Department initiated Amendment

Licence Number	L9013/2016/1
Licence Holder	Gascoyne Resources Limited
ACN	139 522 900
File Number	DER2016/002214
Premises	Dalgaranga Gold Project Mining Lease 59/749 and Miscellaneous Licence 59/151 DAGGAR HILLS WA 6638
Date of Report	4 May 2021
Proposed Decision	Revised licence granted

Figure 1: Standing water levels September 2020 to January 2021

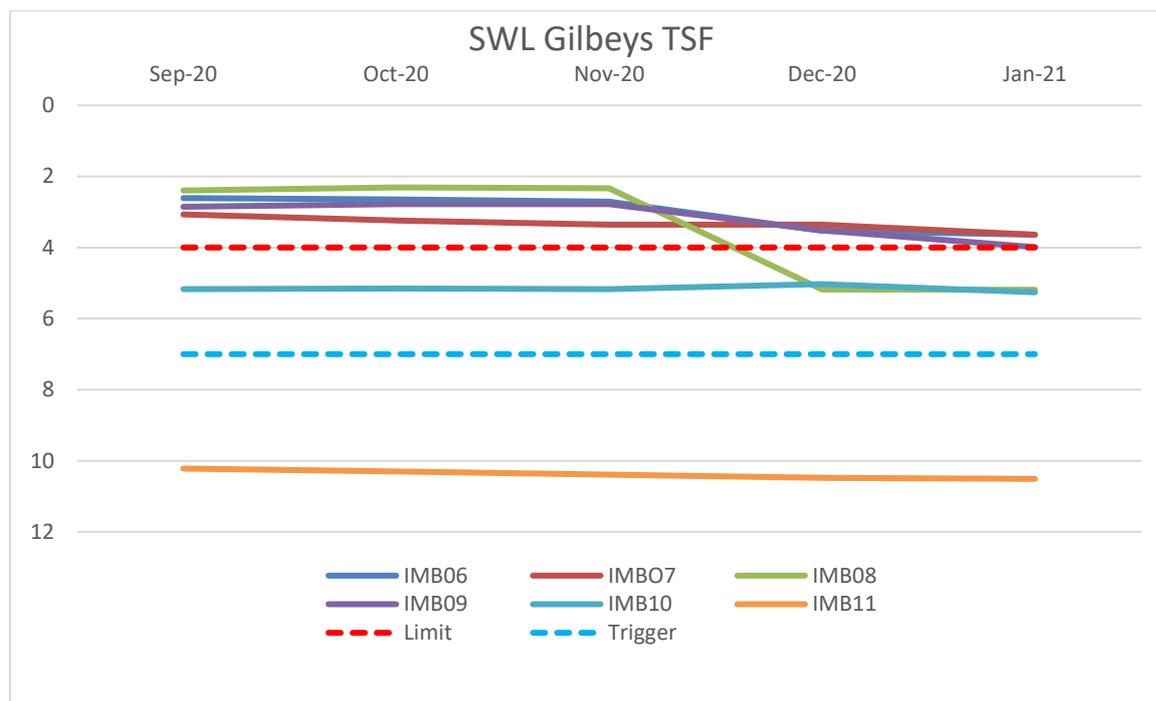
At the time of constructing the new groundwater monitoring bores at the TSF, the Licence Holder observed groundwater levels north west of the TSF were already closer to ground level than the existing Licence limit of 'greater than 4 metres below ground level (mbgl)'. Data collected from the construction of the new groundwater monitoring bores IMB06, IMB08 and IMB09 in August 2020 (see figure 1 below), indicated at that time a SWL of 3.21, 2.83 and 3.31 metres below ground level (mbgl) respectively. These bores are located approximately 400 metres from the crest of the TSF.

The Licence Holder was aware at the time of reviewing the SMP, that the SWL at TSF groundwater monitoring bores IMB06, IMB08 and IMB09 (see figure 2 below) would exceed the proposed new trigger level of 3.5 mbgl, and therefore commenced operating the recently installed TSF recovery bore system (RB13 to RB16, see Figure 2) in late 2020. The results from the use of the recovery bore system are evident in Figure 1 above, whereby SWL's in

groundwater monitoring bores at the TSF are now dropping and are shown to be below the current Licence limit except for groundwater monitoring bore IMB07. Groundwater monitoring bore IMB07 is slightly above the 4 mbgl limit however this also has been trending down.

After considering the data presented and reassessing the risks associated with allowing a reduced minimum depth to groundwater at the TSF, the department now considers the current licence trigger level of 7 mbgl and a limit of 4.0 mbgl for SWL's at the TSF are no longer suitable. Therefore, with the SWL now shown to be greater than 4 mbgl at all TSF monitoring bores with the exception of IMB07 which is only slightly less than 4 mbgl and is trending down, the department considers setting a trigger level of 4 mbgl for all TSF MB's as appropriate. Any exceedance of the SWL trigger value at a TSF monitoring bore will require the Licence Holder to undertake management actions to ensure the SWL is reduced to below the trigger value. These management actions include the use of the TSF recovery bores, investigate why groundwater levels are rising at the TSF and take relevant actions to minimise the likelihood of future increases in the groundwater levels. The management actions are to commence within 30 days of the Licence Holder becoming aware that an exceedance has occurred, and the actions are to continue until groundwater levels fall below the SWL trigger value.

The current SWL Limit of 4 mbgl will also be reduced to 2.5 mbgl. The department considers 2.5 m should be maintained as a minimum depth to groundwater to protection vegetation. An existing condition of the licence requires the Licence Holder to immediately notify the department should an exceedance of any licence limit occur, and to undertake necessary actions.
